Application Number: 10/824,915  
Filing Date: April 15, 2004  
Appellant(s): SELLE, STEPHEN

**EXAMINER'S ANSWER**

► Claims 1 and 3-11 stand rejected under 35 U.S.C. 103(a) as being obvious over Applicant's admission of prior art, in view of either Selle US-6,640,968 or Liestner US-6,209,722.

Examiner's reasonably broad interpretation of Applicant's admitted prior art.

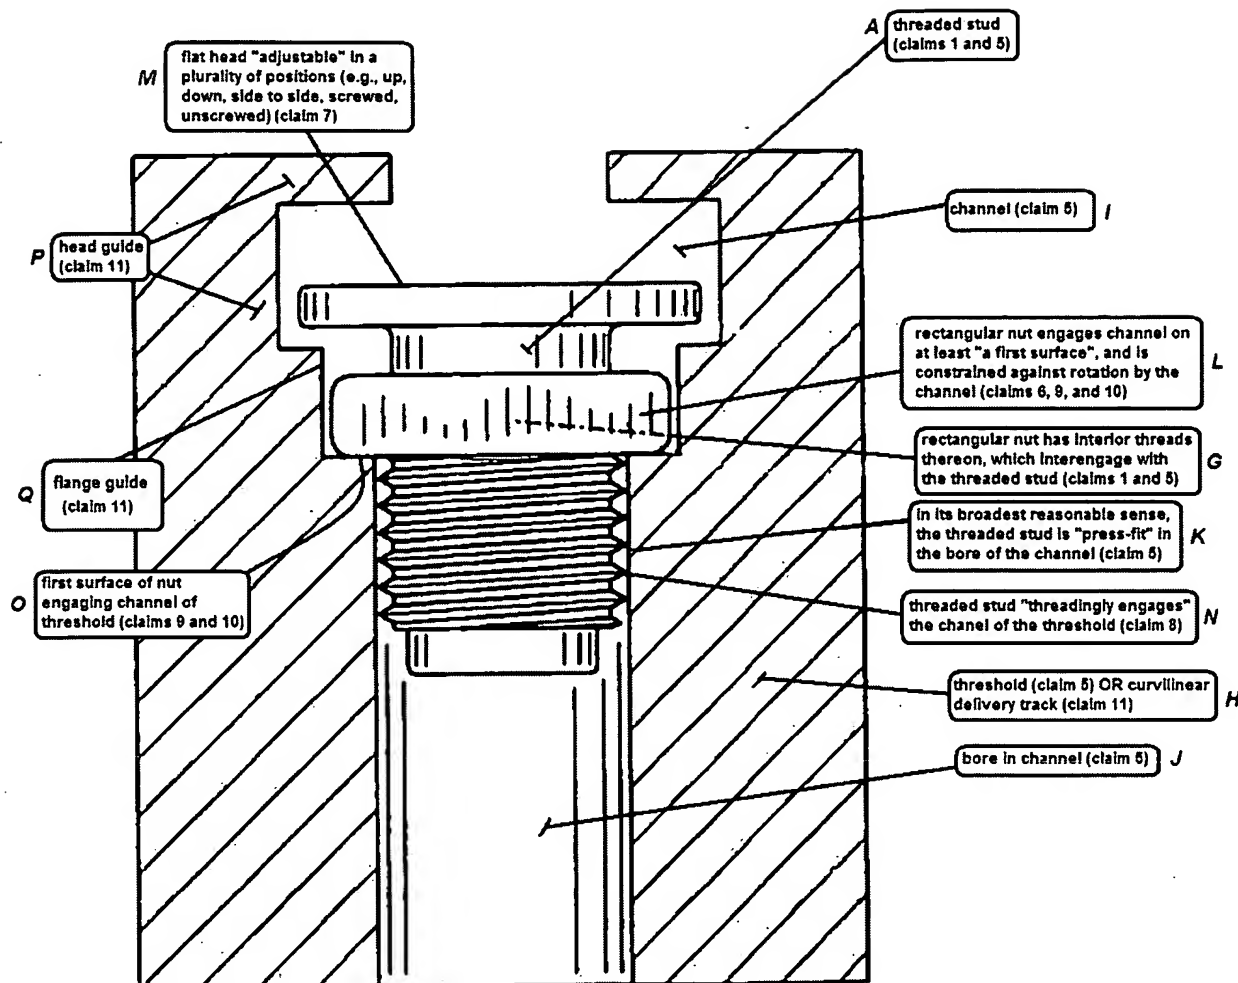
As for claim 1, Applicant discloses as prior art, a fastener comprising a threaded stud (A), a rectangularly-shaped nut (B) having first (C) and second (D) ends, said threaded stud (A) interengaging said rectangularly-shaped nut (B).

As for claim 4, Applicant discloses as prior art, a threaded stud including first (E) and second (F) adjustment receptacles.

As for claim 5, Applicant discloses as prior art, a threshold adjustment device comprising a threaded stud (A), an adjustment receptacle (E,F), a rectangularly shaped nut (B), said threaded stud interengaging said nut (G), a threshold (H) having a channel (I), said channel including a bore (J) therein, said threaded stud being press-fit (K) in said bore (J). Applicant also admits on page 3, line 4 of the specification that it is known to "press-fit" a prior art fastener into a threshold.

As for claim 6, Applicant discloses as prior art, a nut (B) being constrained against rotation (L) by said channel (I).

As for claim 7, Applicant discloses as prior art, a flat head (M), which is adjustable in a plurality of positions.

As for claim 8, Applicant discloses as prior art, a threaded stud (A) threadingly engaging (N) the channel (I) of the threshold (H).

As for claim 9, Applicant discloses as prior art, the nut (B) having a first surface (O) and said first surface (O) of said nut (B) engages the channel (I) of the threshold (H).

As for claim 10, Applicant discloses as prior art, the nut (B) includes a first surface (O) and said first surface (O) of said nut (B) engages the channel (I) of the threshold (H).

Selle US-6,640,968

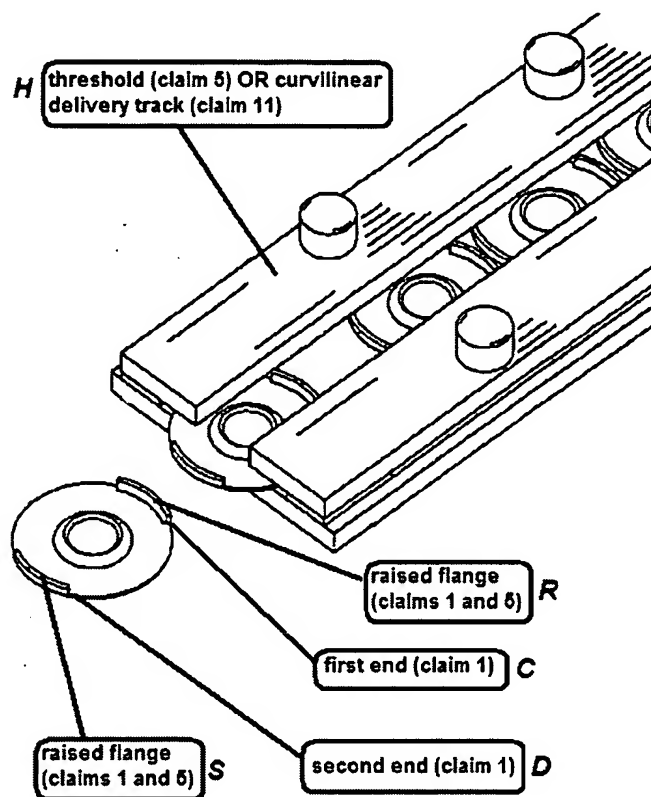
Selle US-6,640,968 suggests employing **raised flanges** (R, S) on first (C) and second (D) ends of a fastener element, so that when said fastener element is placed within a curvilinear

delivery track (H), said raised flanges (R,S) prevent shingling or jamming within said curvilinear delivery track (H). Refer to Selle US-6,640,968, column 1 lines 49-52 and column 3 lines 56-58.

Therefore, at the time of invention, it would have been obvious to those having an ordinary skill in the art, to modify the prior art rectangular nut (B) disclosed in Applicant's admission of the prior art, by employing raised flanges (R, S) on first (C) and second (D) ends of said rectangular nut (B) as suggested by Selle US-6,640,968, in order to prevent shingling or jamming of said rectangular nut (B) when disposed within a threshold (H) or a curvilinear delivery track (H).

**Liestner US-6,209,722**

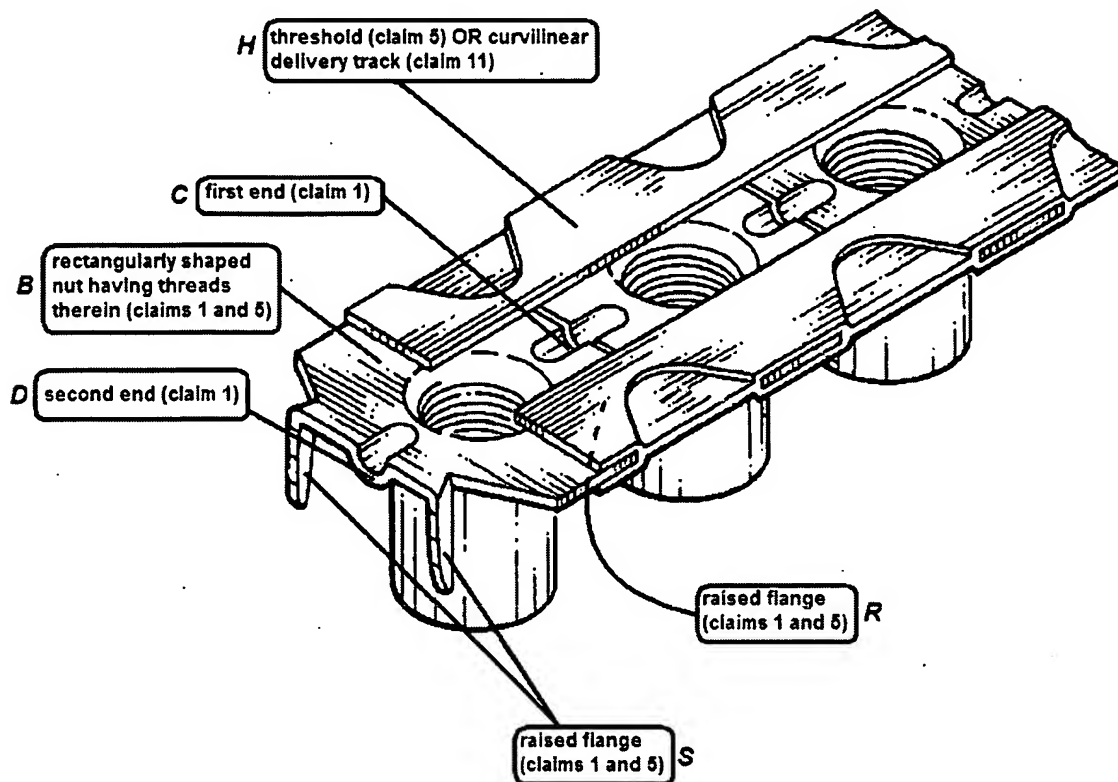
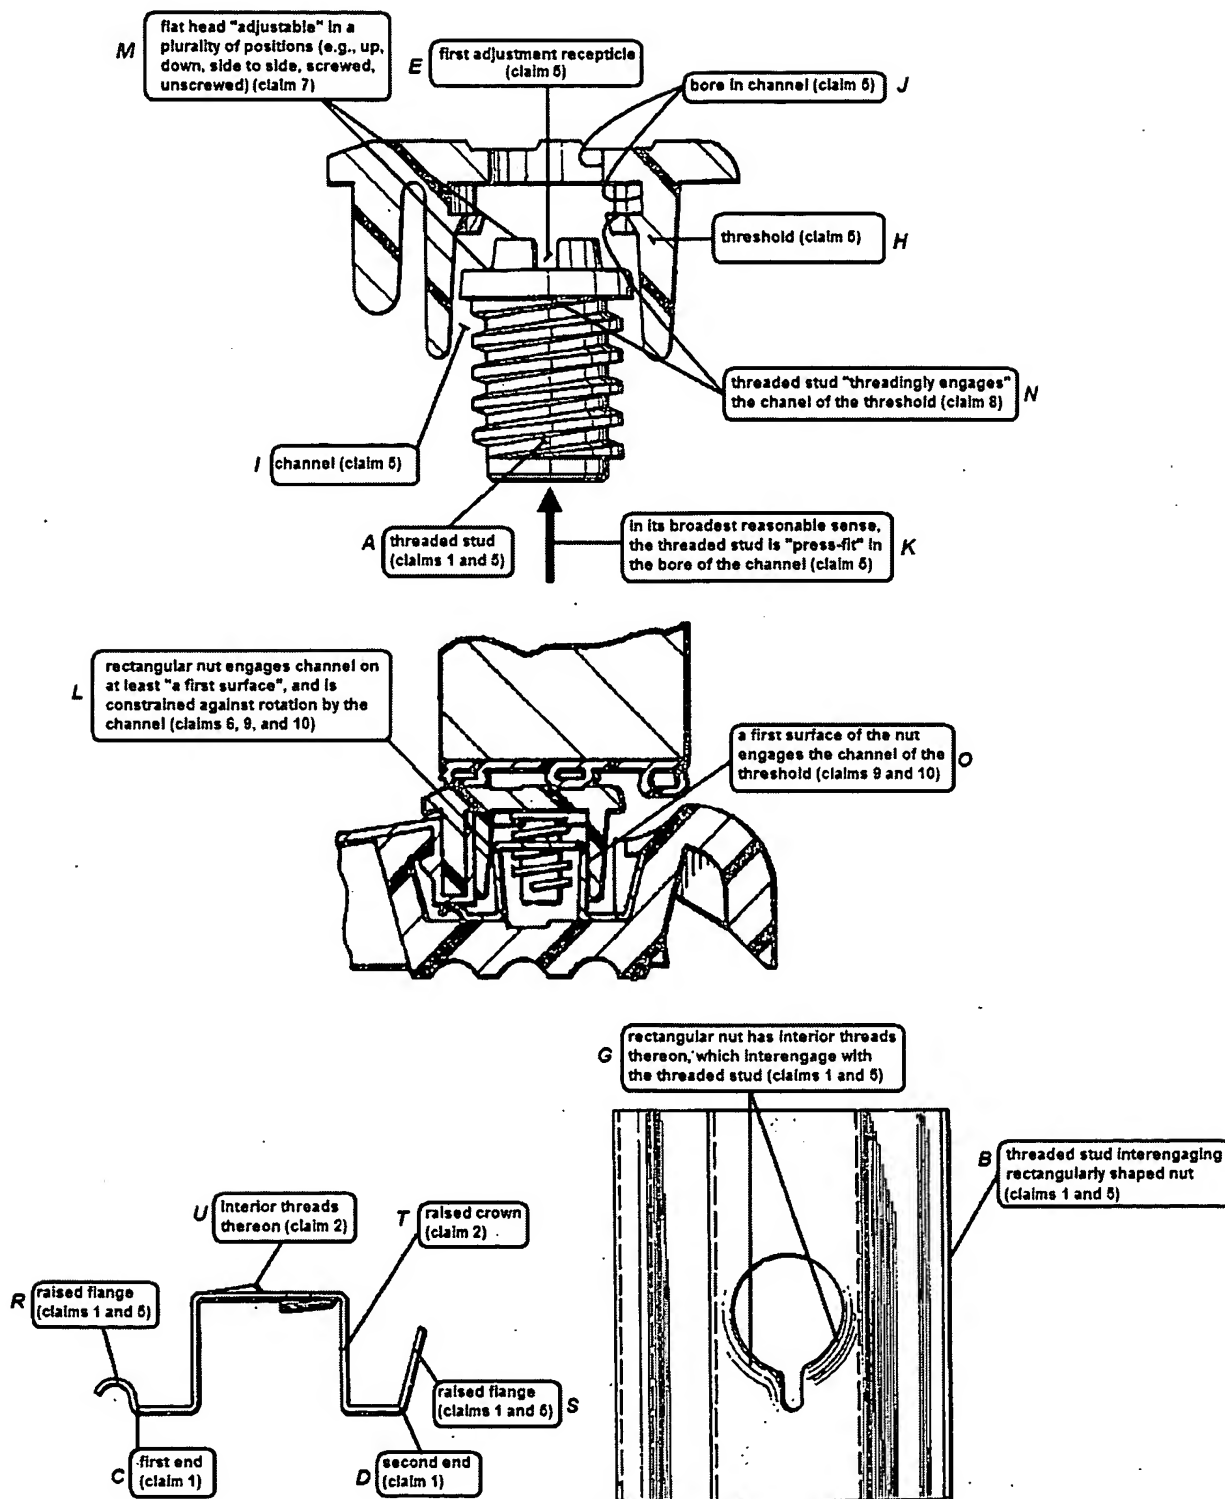
Liestner US-6,209,722 suggests employing **raised flanges** (R,S) on first (C) and second (D) ends of a rectangular nut (B), so that when said nut (B) is placed within a curvilinear

delivery track (H), said raised flanges (R,S) prevent shingling or jamming of said nut (B) within said curvilinear delivery track (H).

Therefore, at the time of invention, it would have been obvious to those having an ordinary skill in the art, to modify the prior art rectangular nut (B) disclosed in Applicant's admission of the prior art, by employing raised flanges (R, S) on first (C) and second (D) ends of said rectangular nut (B) as suggested by Liestner US-6,209,722, in order to prevent shingling or jamming of said rectangular nut (B) when disposed within a threshold (H) or a curvilinear delivery track (H).

Examiner's reasonably broad interpretation of Bursk et al. US-4,352,258.

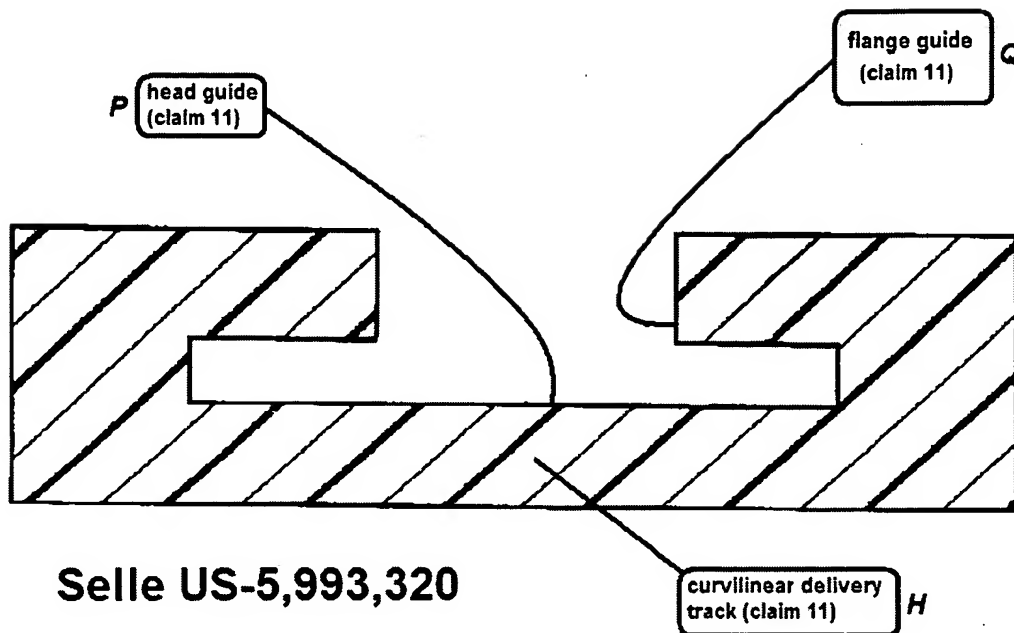
As for claim 1, the Bursk et al. reference discloses a fastener comprising a threaded stud (A), a rectangularly-shaped nut (B) having first (C) and second (D) ends each having a raised flange (R,S), said threaded stud (A) interengaging said rectangularly-shaped nut (B).

As for claim 2, the Bursk et al. reference discloses said rectangularly-shaped nut (B) includes a raised crown (T) having interior threads (U) thereon.

As for claim 3, the Bursk et al. reference discloses said raised flanges (R, S) extending upwardly partially enveloping said threaded stud (A).

As for claim 5, the Bursk et al. reference discloses a threshold adjustment device comprising a threaded stud (A), an adjustment receptacle (E), a rectangularly shaped nut.(B), said threaded stud interengaging said nut (G), a threshold (H) having a channel (I), said channel including a bore (J) therein, said threaded stud being press-fit (K) in said bore (J).

As for claim 6, the Bursk et al. reference discloses a nut (B) being constrained against rotation (L) by said channel (I).

As for claim 7, the Bursk et al. reference discloses a flat head (M), which is adjustable in a plurality of positions.

As for claim 8, the Bursk et al. reference discloses a threaded stud (A) threadingly engaging (N) the channel (I) of the threshold (H).

As for claim 9, the Bursk et al. reference discloses the nut (B) having a first surface (O) and said first surface (O) of said nut (B) engages the channel (I) of the threshold (H).

As for claim 10, the Bursk et al. reference discloses the nut (B) includes a first surface (O) and said first surface (O) of said nut (B) engages the channel (I) of the threshold (H).

Examiner's reasonably broad interpretation of Selle US-5,993,320.

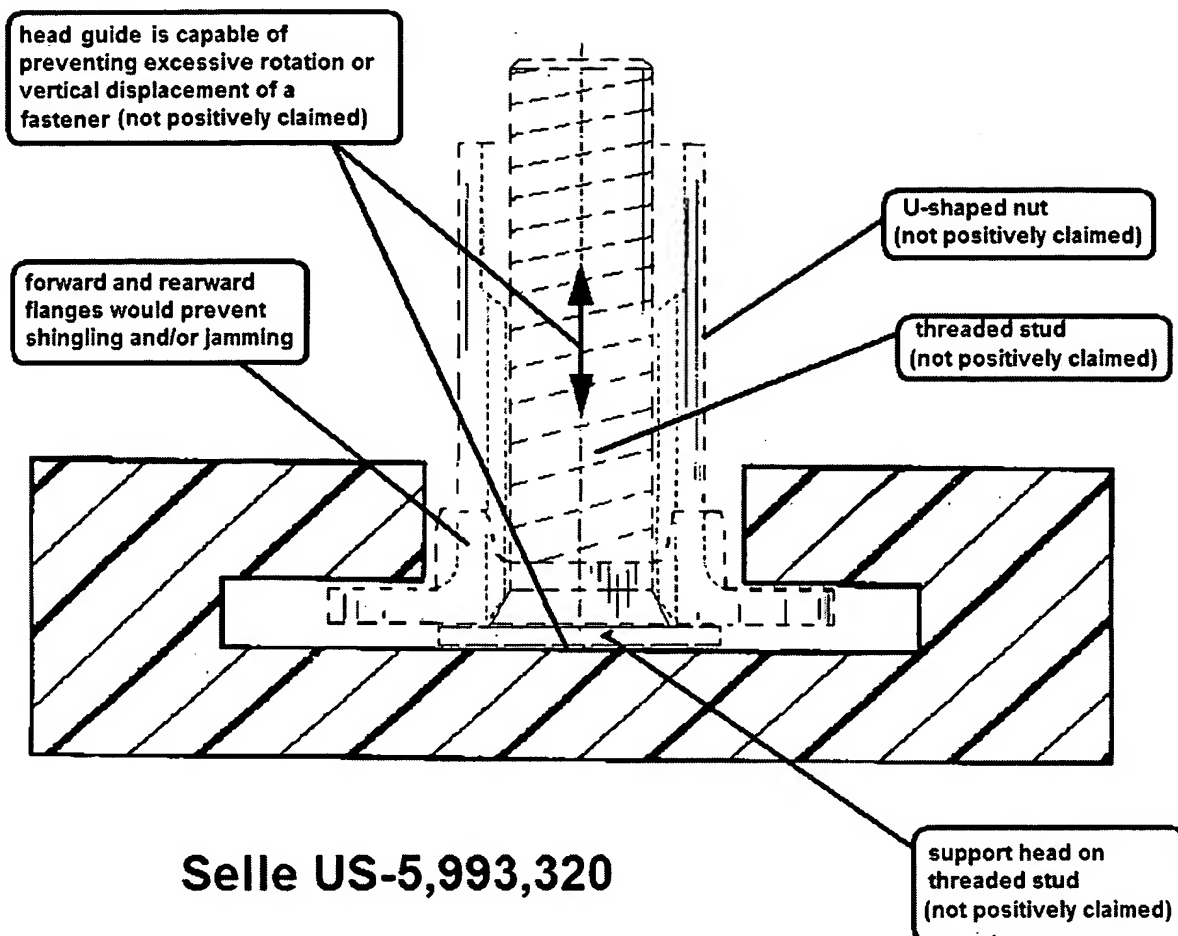
In short, and when claim 11 is given its broadest reasonable interpretation, the Selle reference discloses as prior art, a curvilinear delivery track (H) for delivering a plurality of fasteners, said delivery track (H) includes a head guide (P) and a flange guide (Q). Examiner notes that there appears to be no clear antecedent basis for the limitation "said head guides" (plural emphasis added) on line 5 of claim 11. Examiner further notes that claim 11 has been interpreted as not positively reciting "fasteners", since the preamble only positively recites that the intended use of the curvilinear delivery track is for delivering a plurality of fasteners (emphasis added). The word "for" merely signifies an intended use of the positively recited curvilinear track. Since it is believed by the examiner that no fasteners are positively claimed, the structural and function recitations directed to said fasteners are not given significant patentable merit since they only modify an intended use of the curvilinear delivery track.

Although the plurality of fasteners including a U-shaped nut and a threaded stud are not positively recited in claim 11, it is important to illustrate that the curvilinear delivery track disclosed by the Selle reference is inherently capable of performing the claimed intended use recitations, in order to satisfy the requirements of 35 U.S.C. 102. Accordingly, the examiner has clearly illustrated the capabilities of the curvilinear track disclosed by Selle below (dashed lines are examiner's sketch and are for illustrative purposes only):

Examiner's reasonably broad interpretation of Mettler US-6,185,870

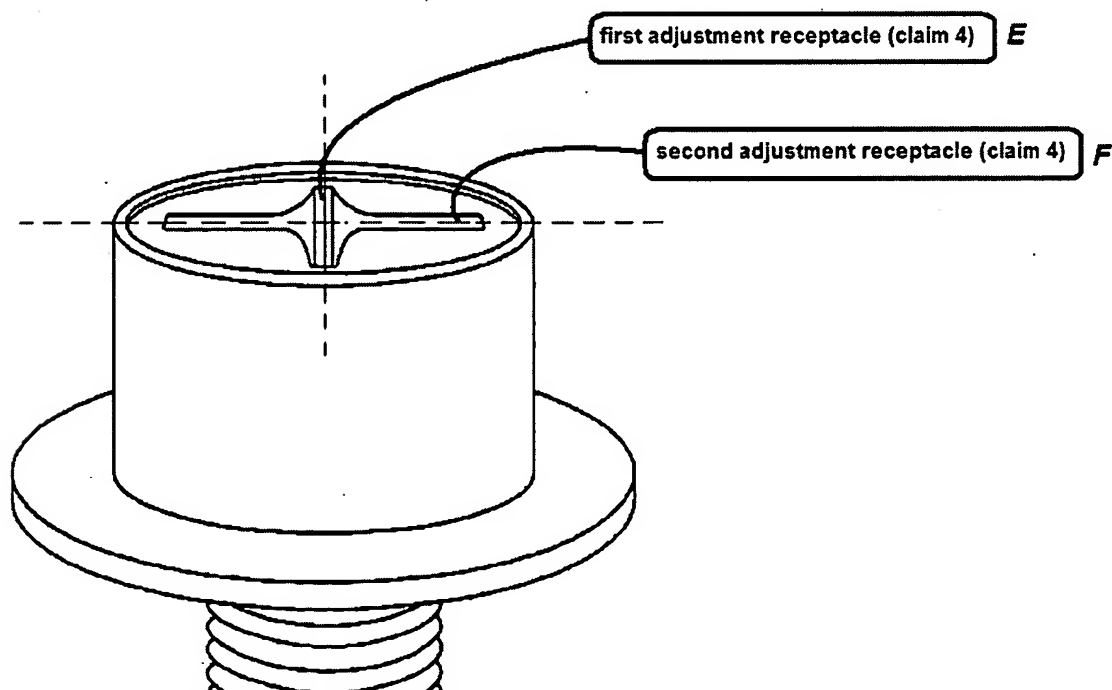
Mettler US-6,185,870 suggests employing a **second adjustment receptacle (F)** to a fastener, in order to allow both a Phillips head screwdriver and a flat head screwdriver to enter therein, making it convenient to adjust said fastener, regardless of which type of screwdriver is readily available.

Therefore, at the time of invention, it would have been obvious to those having an ordinary skill in the art, to modify the fastener taught by Bursk et al., by further employing a **second adjustment receptacle** as suggested by Mettler, in order to provide the fastener with the ability to be adjusted by both a Phillips head screwdriver and a flat head screwdriver.

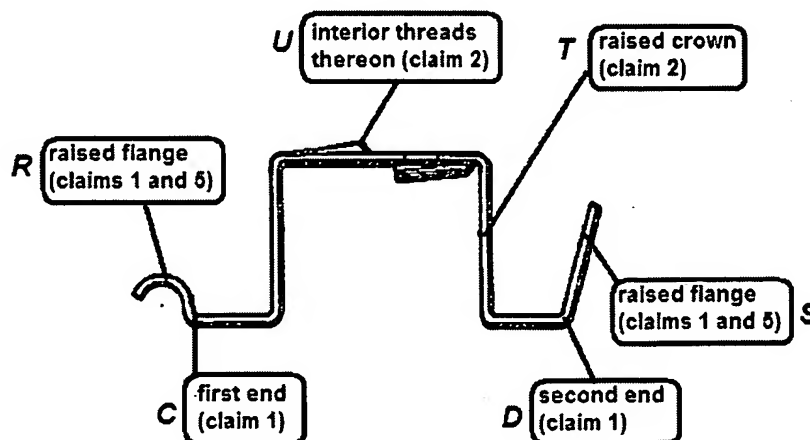
Examiner acknowledges Applicant's statement that Bursk et al. teaches "parts 85, 88 are on the sides of the nut." Applicant appears to argue that the Bursk et al. reference fails to teach raised flanges 85, 88 to be located on the "ends" of the rectangularly-shaped nut. Examiner cannot find a good reason why it would not be proper to broadly construe a "side" as an "end".

For example, where can one of ordinary skill in the art draw the distinction between "a side" of a rectangular object and "an end" of a rectangular object?

Examiner's reasonably broad interpretation of Bursk et al. US-4,352,258.

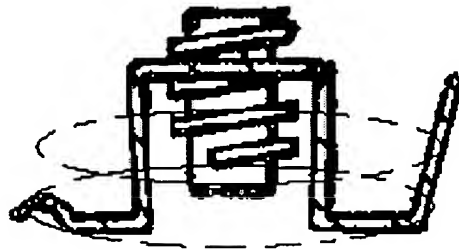
Applicant's argument that the Bursk et al. reference fails to show a crown is not persuasive. As clearly illustrated in the above rejection, the rectangularly-shaped nut disclosed by Bursk et al. has a raised crown (T) having interior threads (U) thereon.

Examiner's reasonably broad interpretation of Bursk et al. US-4,352,258.

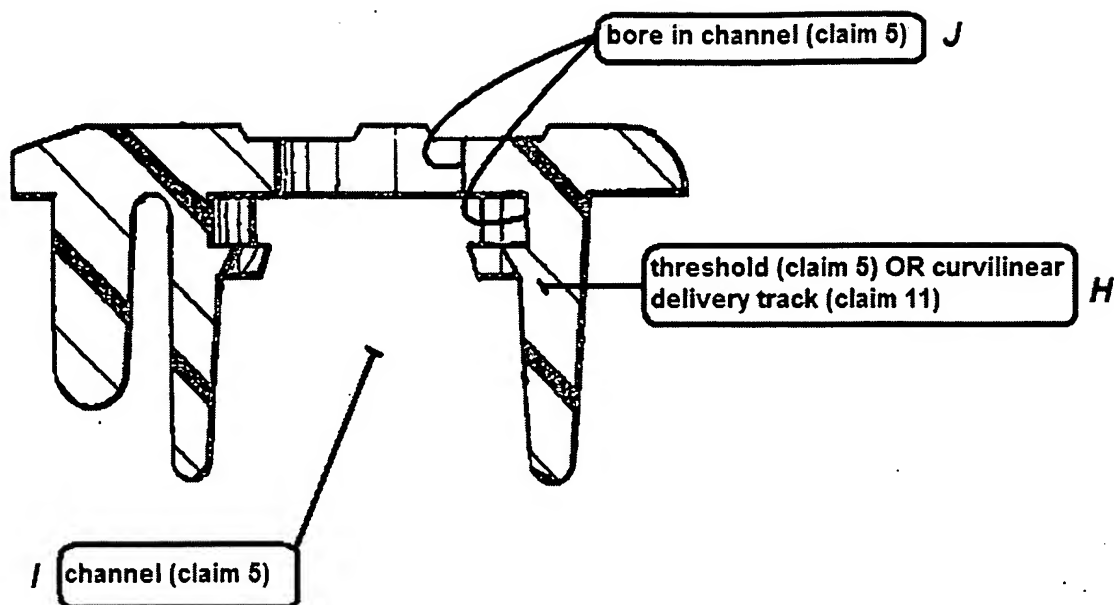
Applicant's allegation that parts 85 and 88 of the rectangularly-shaped nut taught by Bursk et al. are not raised flanges, and do not in any way envelope or surround the stud is acknowledged; however, Examiner feels that in its broadest reasonable interpretation, Bursk et al. does show raised flanges which broadly "envelope" or "surround" the threaded stud.

In response to Applicant's argument that the threaded stud 60 taught by Bursk et al. is not "press-fit" into the bore of the channel, Bursk et al. clearly shows that the threaded stud 60 must be forced upwardly into a bore in the channel in order to be secured thereto.
